UNITED STATES
NUCLEAR REGULATORY COMMISSION
REGION III
799 ROOSEVELT ROAD
GLEN ELLYN, ILLINOIS 60137

Consumers Power Company
ATTN: Mr. R. B. DeWitt
Manager of Nuclear
Plant Operations
212 West Michigan Avenue
Jackson, Michigan 49201

Docket No. 50-155

CONFIRMATORY MEASUREMENTS PROGRAM PERFORMANCE HISTORY FOR BIG ROCK
POINT NUCLEAR PLANT

Figure 1

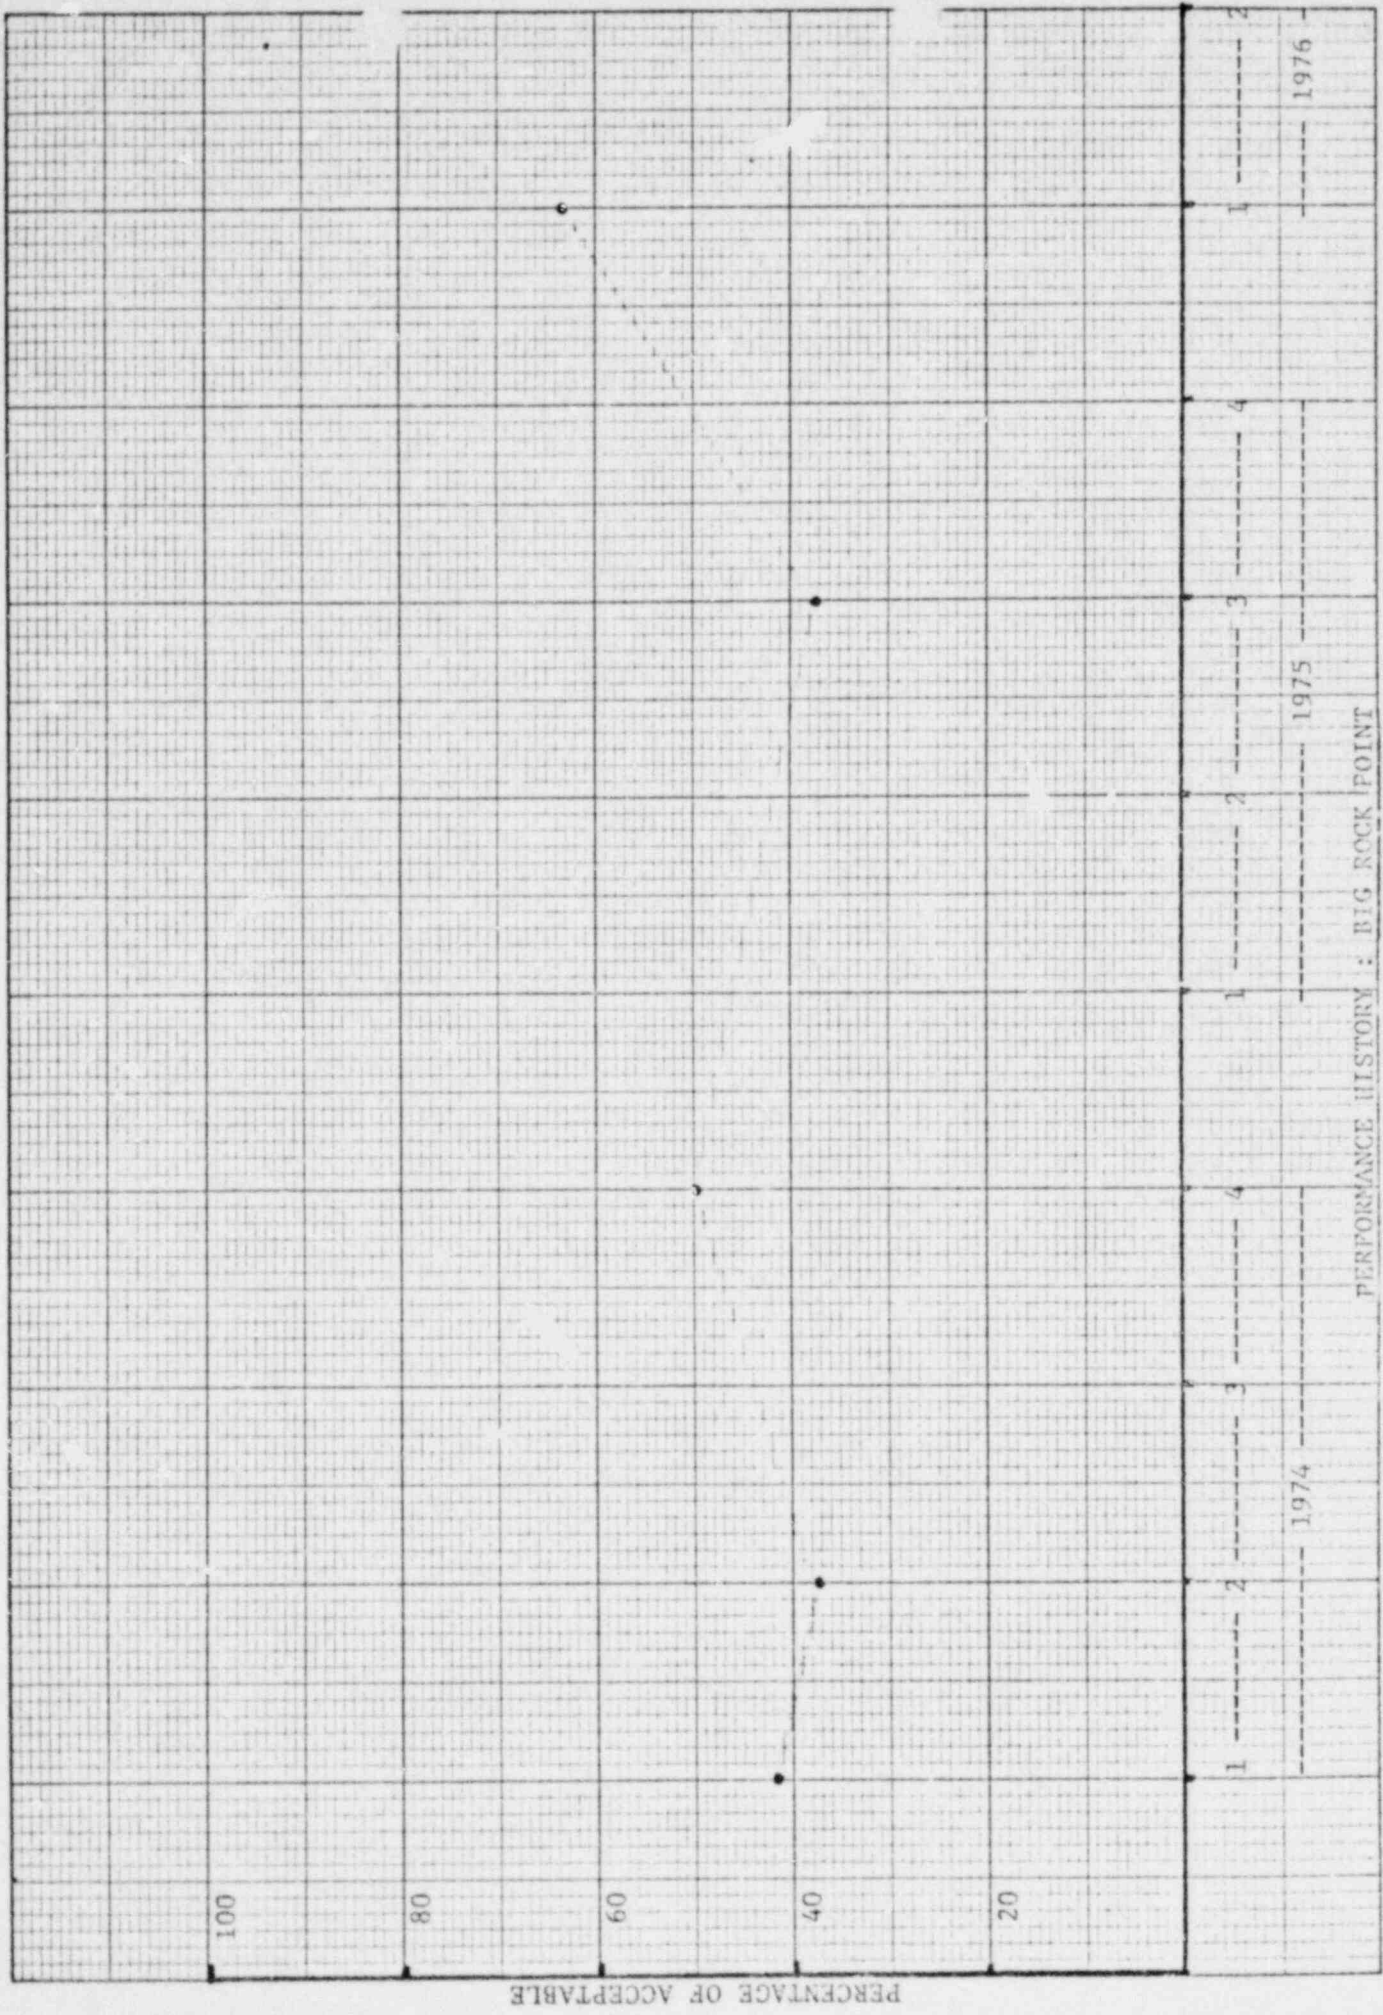
Your Confirmatory Measurements results to date show a substantial number of unacceptable comparisons. Based on these comparisons it is indicative that you may be underestimating radionuclide concentrations in effluents. While this has not led to exceeding your Technical Specifications, the potential for doing so exists. Please advise this office within twenty (20) days of this letter of the steps you have taken to improve the accuracy of your effluent radioanalyses.

The results of the Confirmatory Measurements Program were reviewed using the NRC Computer Data Analysis System. The summary results of these analyses are presented in Table 1. Figure 1 presents performance results as a function of time (trend analysis) for each inspection sample collection period.
